Access Compliance Report

Public Rights-of-Way

Intersection ID: 30454	Main Street: SHALOM PARK DR	Cross Street: PROVIDENCE RD	Location: NW
ADA ID: 1AC771AF1747	Ramp Type: Perp	Initial Pass/Fail: Fail	Overall Compliance: No
		Severity Score: 12.5

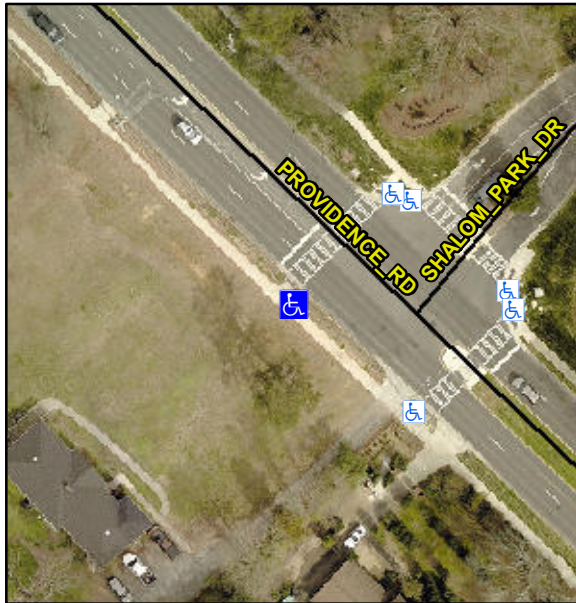
R304.2.2

Compliance	Description	Data	Compliance	Description	Data
N/A	Ramp Length (in)	83.0	No	Ramp Slope (%)	9.1
Yes	Ramp Width (in)	71.0	Yes	Ramp XSlope (%)	0.1
N/A	Flare Type LT	N/A	N/A	Flare Type RT	N/A
N/A	Flare Slope LT (%)	N/A	N/A	Flare Slope RT (%)	N/A
N/A	Flare Traversable LT?	N/A	N/A	Flare Traversable RT?	N/A
N/A	Landing Length (in)	N/A	N/A	DWS Provided?	N/A
N/A	Landing Width (in)	N/A	N/A	DWS Contrast?	N/A
N/A	Landing Slope (%)	N/A	N/A	DWS Length (in)	N/A
N/A	Landing X Slope (%)	N/A	N/A	DWS Full Width?	N/A
N/A	Landing Curb? (Y/N)	N/A	N/A	DWS Offset (in)	N/A
N/A	Shared Landing?	N/A			
N/A	Gutter Ponding?	N/A	N/A	Gutter Slope (%)	N/A
N/A	Gutter Lip Ht (in)	N/A	N/A	Gutter X Slope (%)	N/A
N/A	Painted X Walk1?	Yes	N/A	Painted X Walk2?	N/A
	X Walk 1 Direction	To NE		X Walk 2 Direction	N/A
N/A	X Walk 1 Width (in)	113.0	N/A	X Walk 2 Width (in)	N/A
	X Walk 1 Slope (%)	6.9		X Walk 2 Slope (%)	N/A
	X Walk 1 X Slope (%)	3.9		X Walk 2 X Slope (%)	N/A

Remove & Replace Entire Ramp.
